Bennett Resources Pty Ltd

Valhalla Exploration Drilling Response to Public Submissions – EPA Assessment No. 2281

BNR_HSE_MP_016

Figure 5-1: EPA NetZero Target v Valhalla Emissions

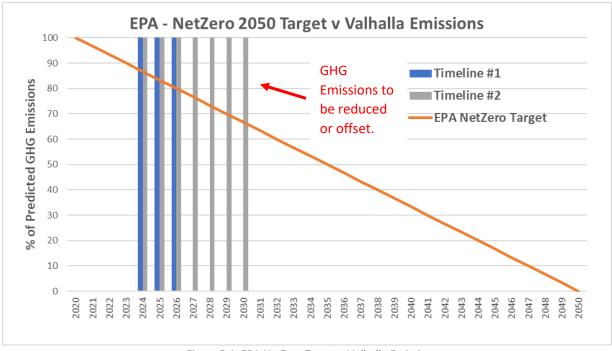
No.	Submitter	Submission and/or issue	Response to comment
49.	ANON-6RBT-RUET-X	Submissions raised concerns regarding the GHG emissions estimates presented by the proponent: There is a huge, unexplained discrepancy in maximum emissions that could be generated by the project. Based on Figure 3-1 (Timeline for overall scope 1 GHG emissions of the Valhalla E&P Program) in the GHGEMP, the total project emissions would be approximately 2.64 Mt CO ₂ e, rather than 1.6 Mt.	BNR has updated the Greenhouse Gas Environmental Management Plan (GHGEMP) refer to Appendix 5 to reflect the correct figure, now Figure 3-1.
		The assessment should be based upon flaring for 90 days rather than 60 days, consistent with the proponent's statements (including in the s43A document) that only a 90 day flaring option is being considered.	The assessment is based upon maximum predicted emission levels. All considerations are based upon flaring for 90 days.

The "NetZero 2050" target stated in the GHGEMP related to the WA EPA Greenhouse Gas environmental factor guidelines. The 100,000 tonnes stated in the guideline is not a baseline value but rather a threshold. Section 5.1, figure 5-1 (pg. 59) of the GHGEMP states: "provides a quantitative estimate of maximum GHG emissions and the reductions/offsets that could be mandated by EPA under the NetZero 2050 trajectory for the Valhalla E & A program under each of the two timelines considered. Depending on how EPA would assess a shale gas exploration project, BNR may or may not be required to offset part of the GHG emissions associated with the Valhalla E & A program beyond the annual EPA NetZero targets."	BNR has discussed the application of the guidelines to exploration projects with DWER in detail. The GHGMP has been developed in line with the requirements of the time and updated consistently as policy has changed since it was first developed. BNR has committed to thresholds and targets consistent with the EPA requirements for GHG Management plans. However, it should be noted the faster works are completed the greater the emissions per year and the greater the application of safeguard. Thus, sufficient regulation exists either through the application of the GHGEMP and BNRs commitment to meet the identified targets OR through application of Safeguard Mechanism. For further information regarding the safeguard, refer to:

0 1 ""		
No.	Submitter	Submission and/or issue	Response to comment
		Corollary to this, the Peer Reviewer agreed that a baseline of 100,00 tonnes CO2-e is provided by the WA EPA, with the emissions trajectory given in Figure 5-1 (pg. 59); pg. 19 of the GHGEMP crystallises the offset requirements calculated by the proponent where "the expected maximum carbon offsets needed after the fifth year of operations would be 22,763 tCO2e/well in phase one, and 39,588 tCO2e/well in phase two."	
		The statement on pg. 59 of the GHGEMP, "hence, it would be beneficial for BNR to commit to a faster overall development timeline in a NetZero carbon environment" is highly concerning." This implies that the quicker the project is completed, the less offset / emissions reduction is required and is part of the GHG reduction strategy – this is not aligned to the intent of best practice.	
		The GHGEMP recognised the Safeguard Mechanism baseline for the project, but it does not describe it. Page 38 of the GHGEMP states that "the safeguard mechanisms applies to facilities with direct emissions (scope 1) in exceed of 100,0000 tonnes CO2- e per annum".	Oil and gas exploration activities are reportable under the National Greenhouse and Reporting (NGER) scheme and can be covered by the Safeguard Mechanism if those activities form part of a facility that triggers the Safeguard Mechanism threshold. BNR acknowledge that the threshold for application of the safeguard is accordance of 100 0000 tennes CO2 a per annum. Two of the key project.

Appendix 8. Figure showing Mount Wynne Creek and Mount Wynne Seep

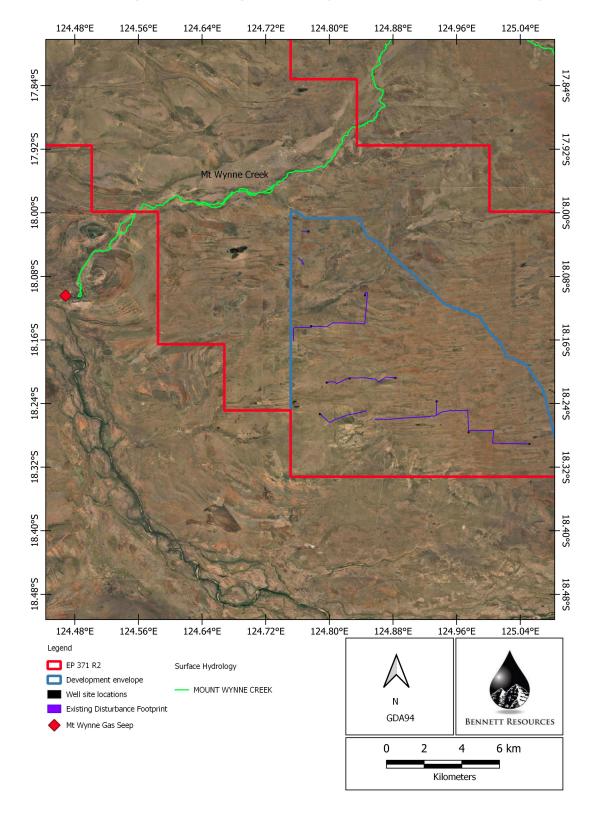
Groundwater modelling indicates drawdown to be limited to 1 mm at 700 m from abstraction points (located at the wellsite). Clarification, including a figure, should be provided around the location of mapped water features within the 700 m drawdown zone of each abstraction point. From this analysis, provide further comment as required on any potential indirect impacts to surface water features resulting from groundwater drawdown.
